HDRC CASE NO: 2021-074

COMMON NAME: ROW near 121 S Flores

TYPE OF WORK: Replace an existing streetlight pole with a new pole with network node equipment

HDRC HEARING Verizon Wireless

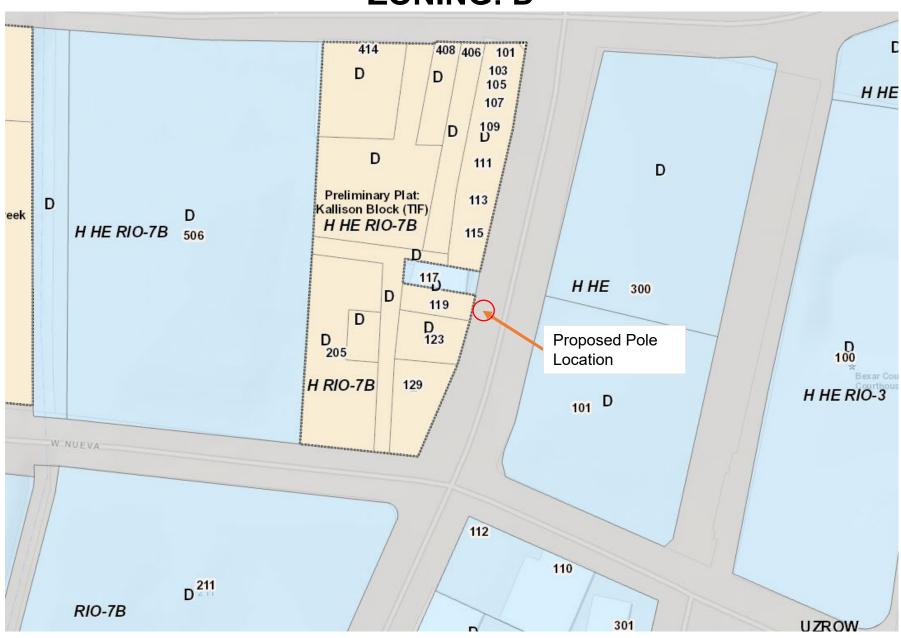
This application was originally on the October 21, 2020 HDRC agenda but was subsequently pulled off the agenda by a couple members of the HDRC due to concerns of the pole being directly in front of the front façade of the adjacent building.

Verizon met with the HDRC subcommittee on October 28th, 2020 to discuss the concerns some of the commission members had regarding the location of the replacement CPS streetlight. Directive from that meeting was to explore options with CPS on the feasibility of shifting the replacement of the replacement streetlight to a location that would be between two buildings rather than directly in front of the façade.

Verizon broached this question to CPS. CPS reviewed this location and did their own internal photometric study to ensure that the shift of the lighting structure would not impact their street lighting requirements in the area. Unfortunately, CPS informed us that they would not allow for the shift in location due to concerns over the negative impacts on the lighting along Flores St.
